Consent Agenda Item (Action Item): Consider/Approve Change Order NO. 7-1 for the Betsy Layne High School Renovation and Addition to Elliott Contracting (BG# 16-143).

BG Number: 16-143 (Imported Project) Betsy Layne Renovation and Addition

7-1 Change Order Number

Work Changes Proposal Request

ELOVID COUNTY, KY E5.3 SECOND ELOOR - SYSTEMS BETSY LAYNE HIGH SCHOOL PHASE I ADDITION 可提 KEY PLAN

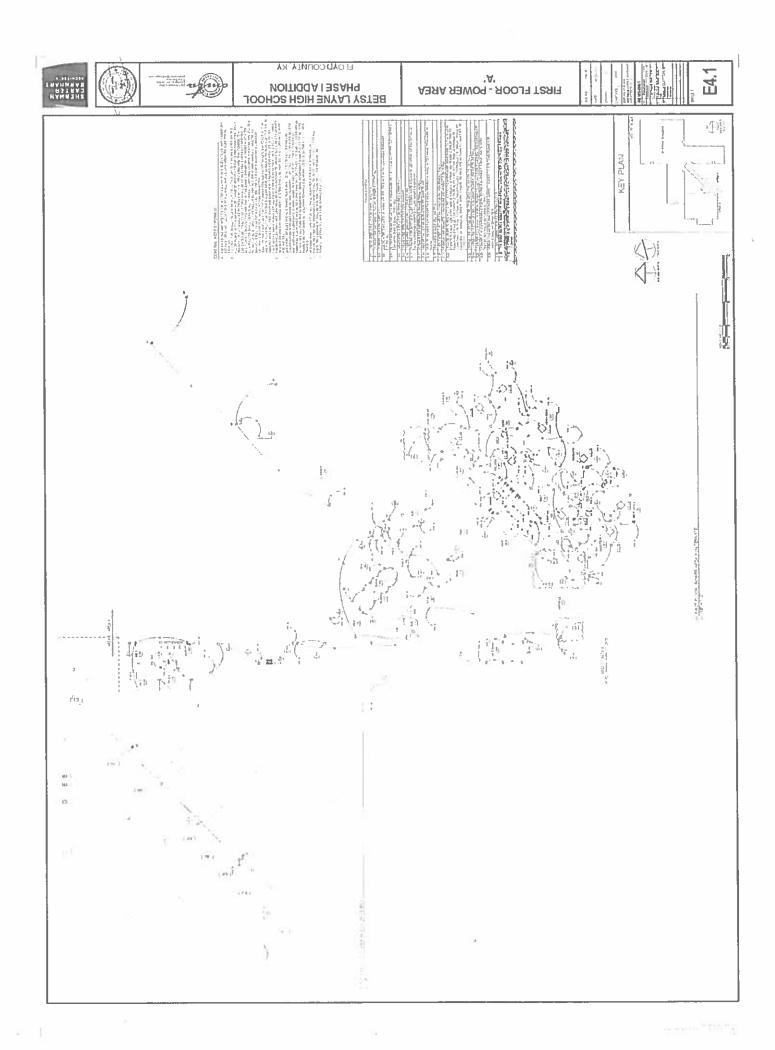
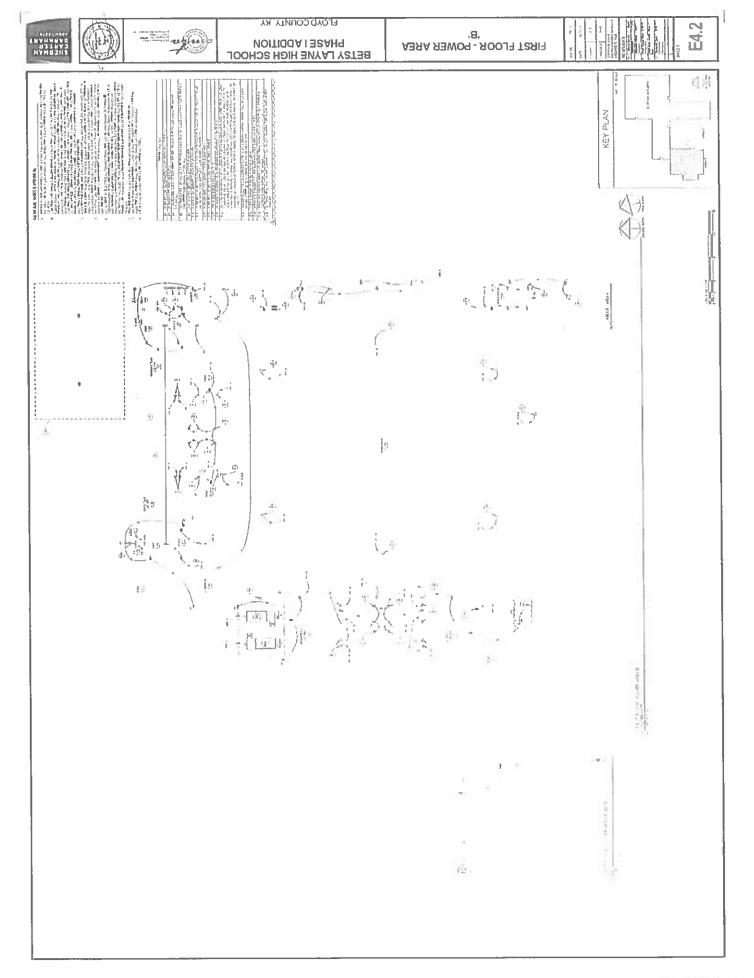
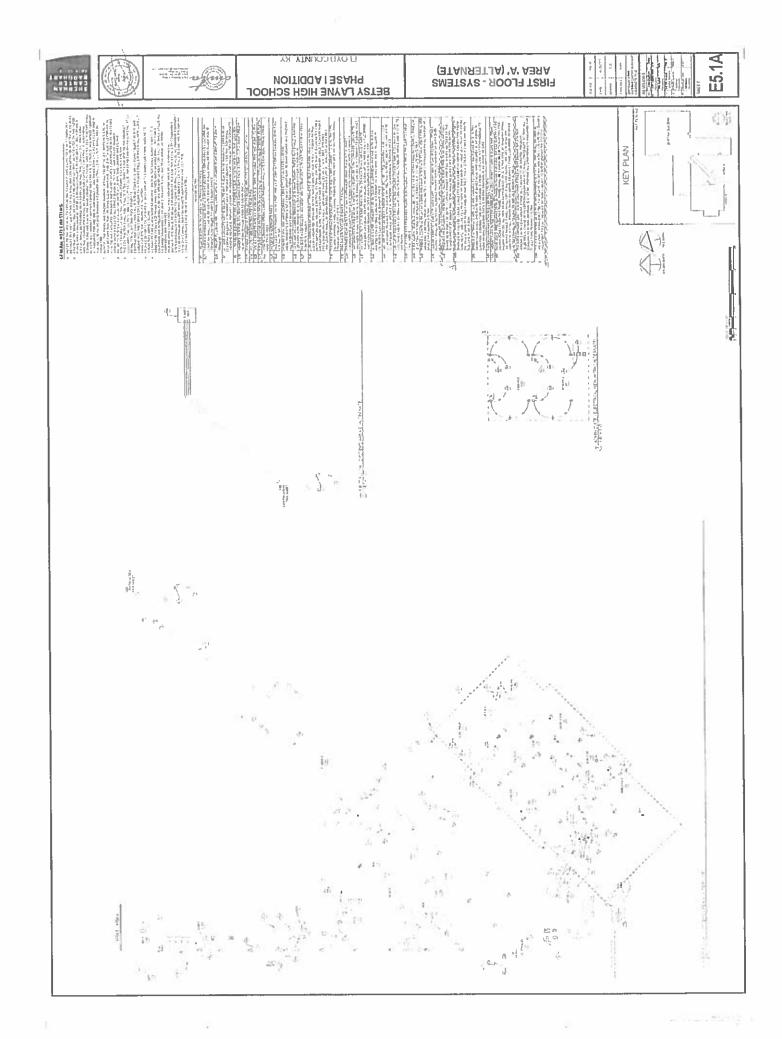
Door Hardware Revisions, CMTA Verbiage, Sheets E4.1, E4.2, E5.1A, E5.3

- 1. Provide credit for the following:
 - a. Delete card readers and associated conduit and wiring at the following doors: 104B, 112A, 117, 119, 119A, 203, 204B.
 - b. Delete video intercom remote station at door E100B and video master station located in reception.
 - c. Delete magnetic door holds at the following doors: 100A, 101A, 104A, 104B.
- 2. Provide price for the following:
 - a. Provide audio intercom master station at reception desk and audio intercom remote station at door 101A as shown on attached drawing.
 - b. Relocate remote release from door E100B to 101A.
 - c. Programming indicated in note \$48.
 - d. Power at doors indicated for door hardware power as required.

Refer to included drawings for additional information.
